TCP/11/16(506) – 17/01339/FLL – Erection of a dwellinghouse on land 40 metres north of The Stables, Main Street, Almondbank

TCP/11/16(506) – 17/01339/FLL – Erection of a dwellinghouse on land 40 metres north of The Stables, Main Street, Almondbank

PROPOSED DWELLING ON LAND BETWEEN WOODEND COTTAGE AND THE STABLES, MAIN STREET, ALMONDBANK PLANNING APPLICATION REFERENCE NO: 17/01339/FLL

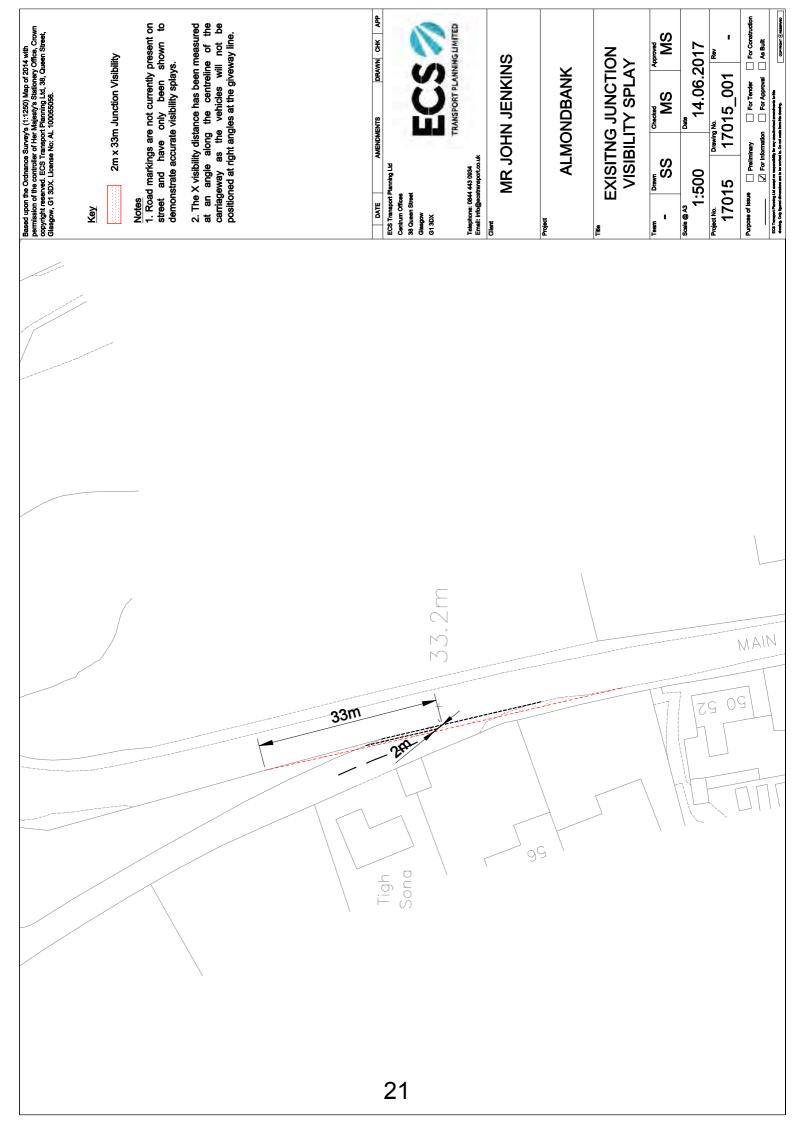
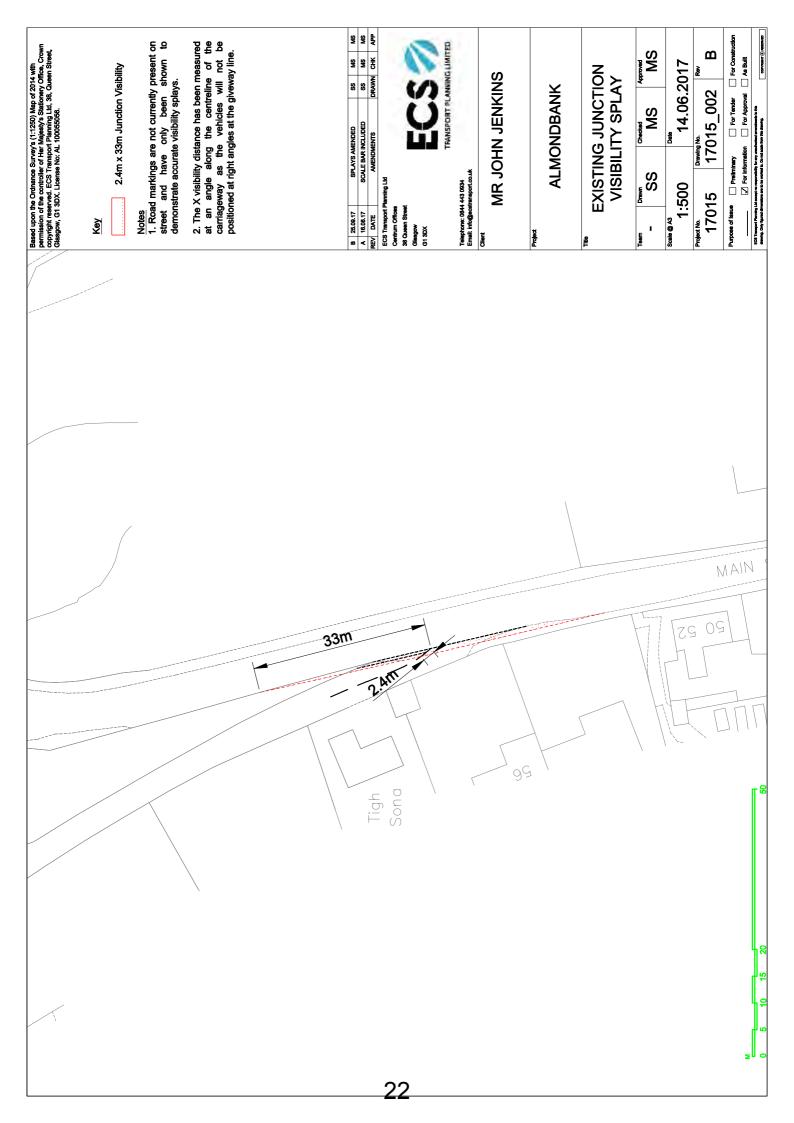
The ECS letter written in support of the application refers to a visibility splay of 2m x 33m as being appropriate for the junction, and includes drawing number 17015_001 which seeks to demonstrates that this visibility splay can be achieved. Both the visibility splay referenced and the drawing produced are flawed.

Drawing 17015_001 prepared by ECS also wrongly represents the 2m x 33m visibility splay as a result of how the 2m 'X' distance has been measured. Normally the 'X' distance would be measured back from the major road channel at 90 degrees. In this case the existing junction has a very acute angle, to the extent that a car does not sit at 90 degrees when waiting to exit the private access. So, it is accepted that the 'X' distance measurement should realistically be angled. However, the ECS drawing does not accurately reflect the position of a driver when waiting to exit the private access, unless a significant proportion of the car was to protrude into the Main Street carriageway.

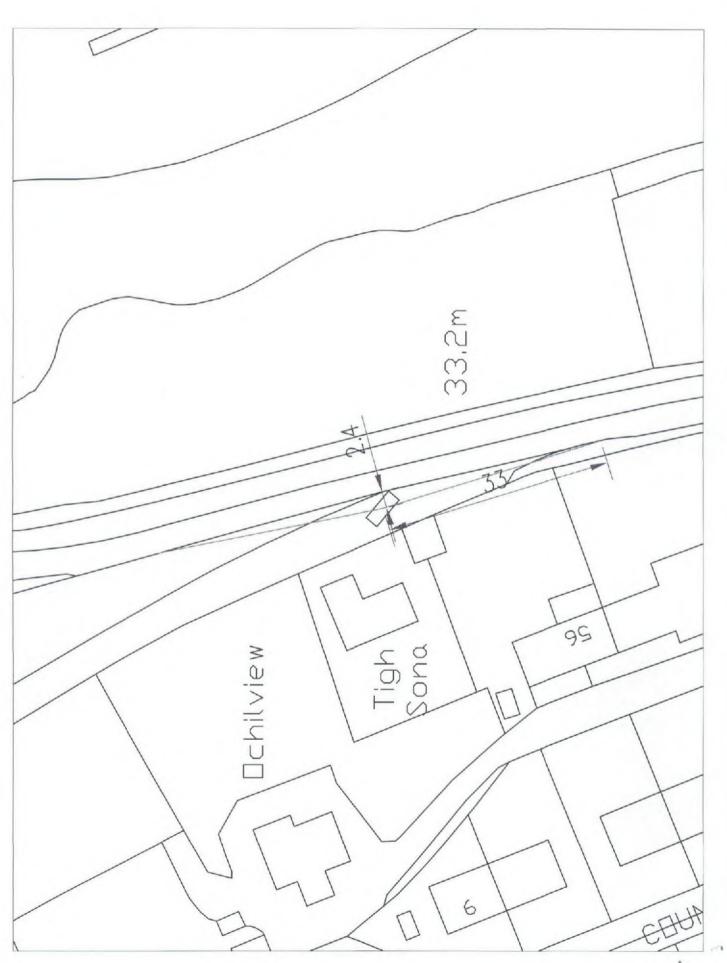
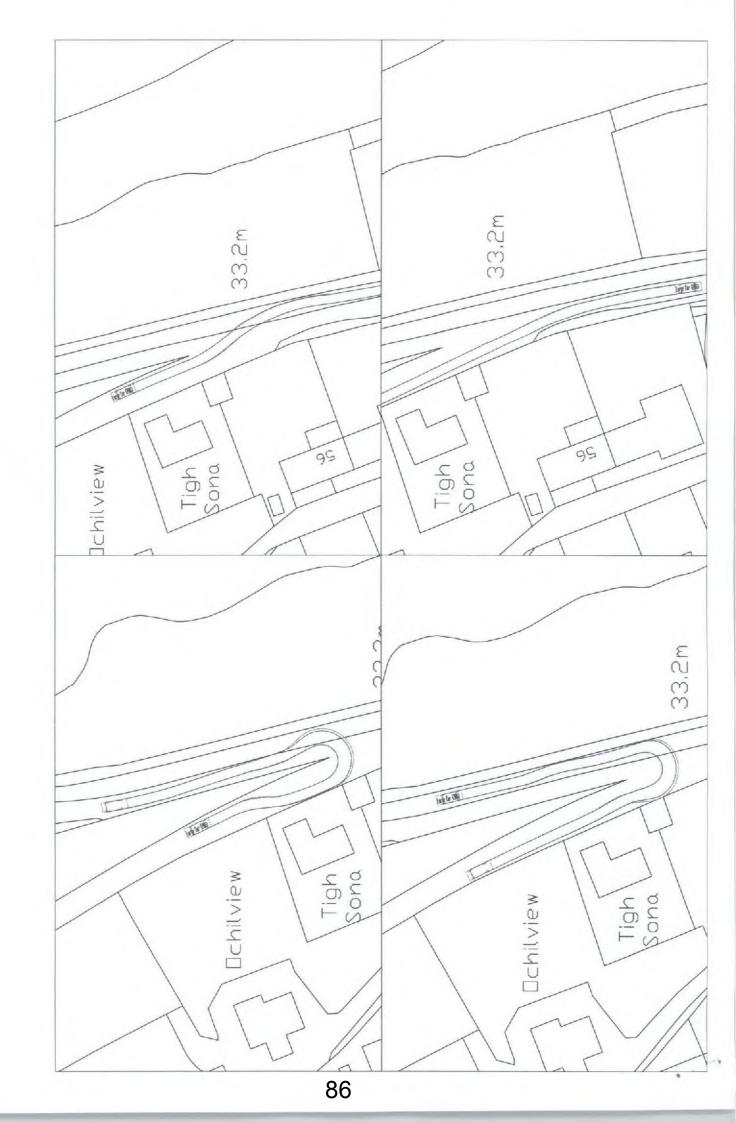
A drawing is enclosed which is based on a 2.4m x 33m visibility splay, measured from a more appropriate location on the private access, which reflects driver position. This is also demonstrated by Photograph 3. The drawing and photograph show that visibility to the north is hampered by a private wall. There used to be a pillar on the end of the wall which was vandalised, but if replaced it will further hinder available visibility. From a 2.4m 'X' distance drivers should be able to see the

whole carriageway for the entire 33m 'Y' distance, between a height range of 600mm to 2m above the carriageway channel. This visibility requirement cannot be achieved without crossing private land, and topography also restricts visibility in the vertical plane, as shown in Photograph 3. The applicant does not have control over private walls so cannot provide necessary improvements.

Photograph 3

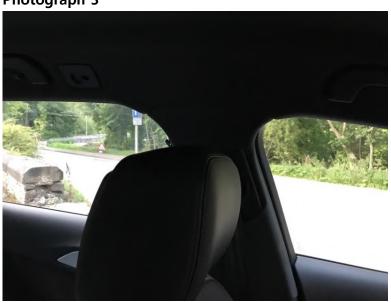
It is also perhaps pertinent to note that the unsatisfactory visibility available to drivers exiting the private access remains, despite the suspicious and unlawful removal of the two ton stone pillar at this junction - the removal of which occurred shortly before the first application by Mr Jenkins - and which was deemed an act of criminal vandalism during the subsequent police investigation. The base of the pillar can still be seen in **Photograph 2**.
